March 12, 2013  
Subject: **Portland Marine Terminal**  
State WIN: 018413.10  
**Amendment No. 1**

This project titled, "Portland International Marine Terminal Improvements, Phase 2 – Electrical Improvements," consists of making electrical improvements at the International Marine Terminal (IMT) in Portland, Maine during active facility operations. This work is in support of Eimskip, Inc., an Icelandic shipping firm whose operations include shipping refrigerated cargo containers through the Portland IMT facility, and is critical to time sensitive business development opportunity.

PORTLAND INTERNATIONAL  
MARINE TERMINAL IMPROVEMENTS  
PORTLAND CUMBERLAND COUNTY  
**PROPOSED SITE SECURITY AND  
ADDITIONAL WORK ELEMENTS**

SHEET NUMBER  
**A1**

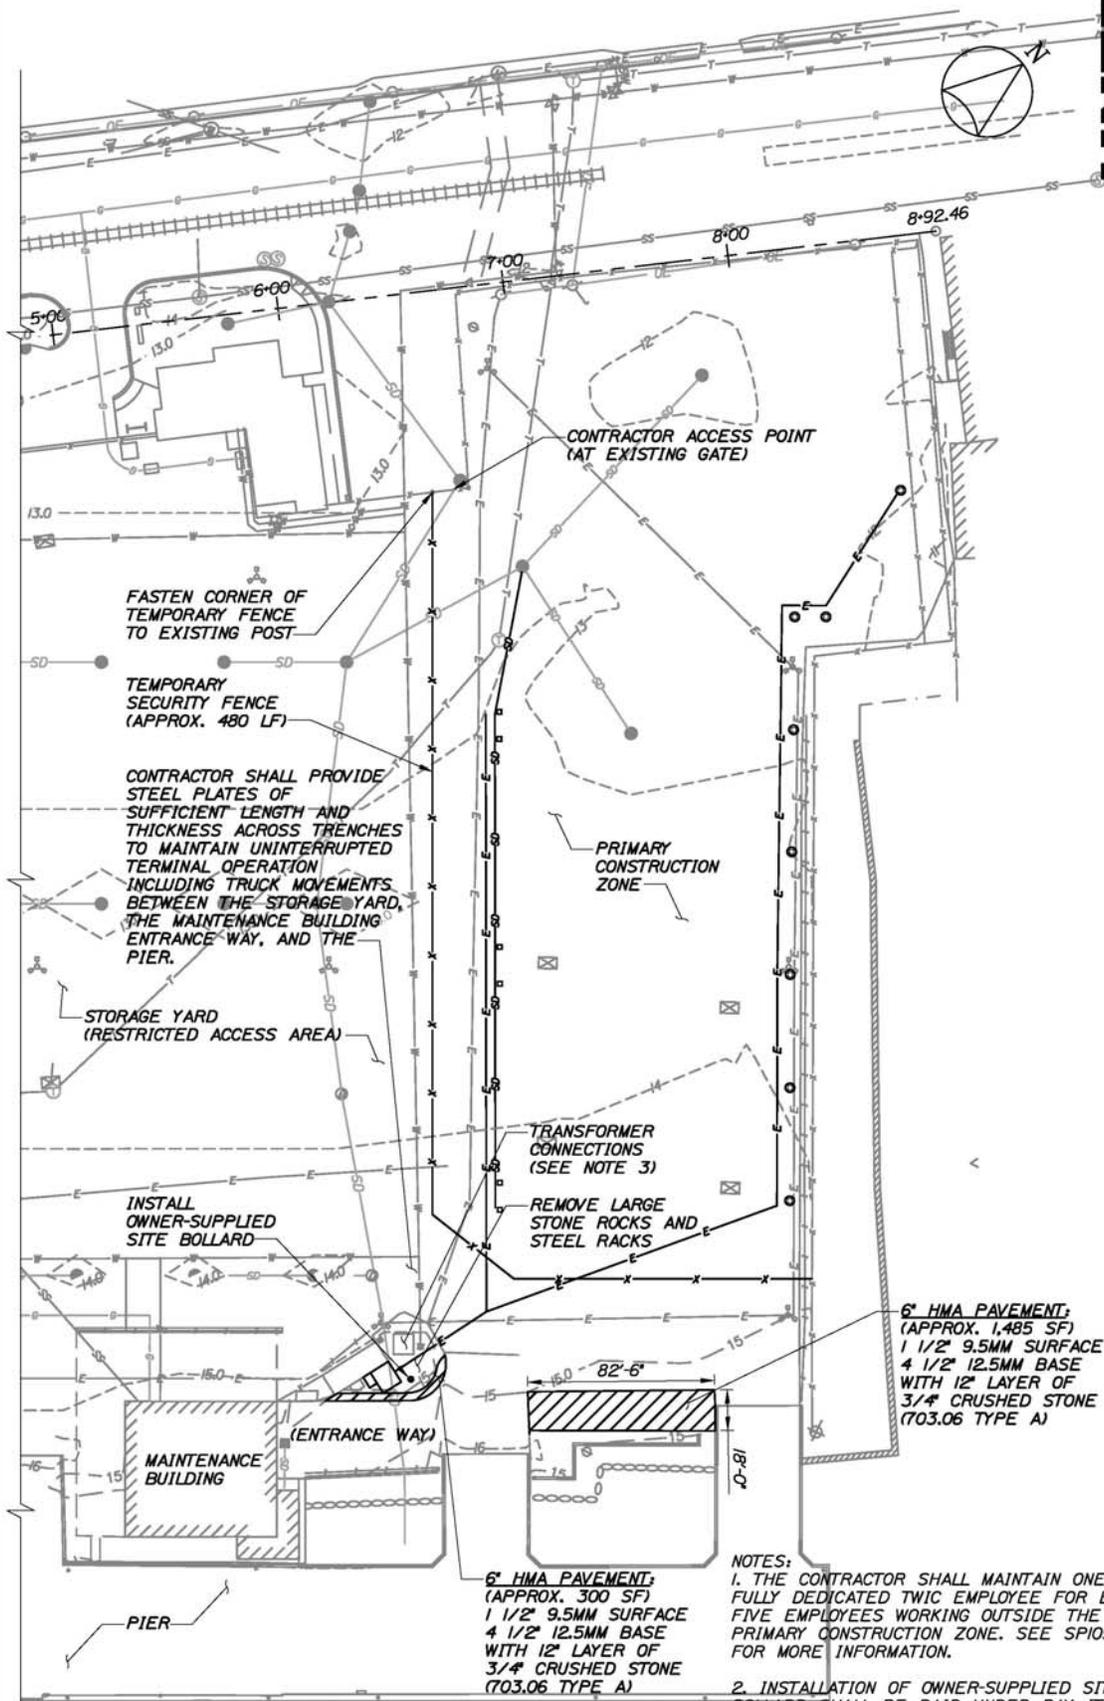
In the Bid Book (page 79), **CHANGE** the second sentence of the second paragraph of Subsection 815.98 to read as follows, “**The lump sum price of the Utility Building – Concrete Foundation shall also include the removal and on-site storage of the large rocks and steel racks alongside the existing utility building near the existing electrical transformer, and shall also include the installation of an owner-supplied site bollard as shown on Sheet A1.**” Make this change in pen and ink.

In the Bid Book after page 80, **ADD** the attached “SHEET NUMBER A1, PROPOSED SITE SECURITY AND ADDITIONAL WORK ELEMENTS”.

FASTEN CORNER OF TEMPORARY FENCE TO EXISTING POST

TEMPORARY SECURITY FENCE (APPROX. 480 LF)

CONTRACTOR SHALL PROVIDE STEEL PLATES OF SUFFICIENT LENGTH AND THICKNESS ACROSS TRENCHES TO MAINTAIN UNINTERRUPTED TERMINAL OPERATION INCLUDING TRUCK MOVEMENTS BETWEEN THE STORAGE YARD, THE MAINTENANCE BUILDING ENTRANCE WAY, AND THE PIER.

INSTALL OWNER-SUPPLIED SITE BOLLARD

REMOVE LARGE STONE ROCKS AND STEEL RACKS

6" HMA PAVEMENT; (APPROX. 1,485 SF)  
1 1/2" 9.5MM SURFACE  
4 1/2" 12.5MM BASE WITH 12" LAYER OF 3/4" CRUSHED STONE (703.06 TYPE A)

6" HMA PAVEMENT; (APPROX. 300 SF)  
1 1/2" 9.5MM SURFACE  
4 1/2" 12.5MM BASE WITH 12" LAYER OF 3/4" CRUSHED STONE (703.06 TYPE A)

NOTES:  
1. THE CONTRACTOR SHALL MAINTAIN ONE FULLY DEDICATED TWIC EMPLOYEE FOR EVERY FIVE EMPLOYEES WORKING OUTSIDE THE PRIMARY CONSTRUCTION ZONE. SEE SPIO5 FOR MORE INFORMATION.

2. INSTALLATION OF OWNER-SUPPLIED SITE BOLLARD SHALL BE PAID UNDER PAY ITEM 815.272 UTILITY BUILDING - CONCRETE FOUNDATION.

3. CONTRACTOR SHALL COORDINATE WITH CMP TO CORE THE VAULT FOR CONDUIT PENETRATIONS AND FINAL CONNECTIONS TO THE TRANSFORMER. PAYMENT SHALL BE INCIDENTAL TO PAY ITEM 626.45.
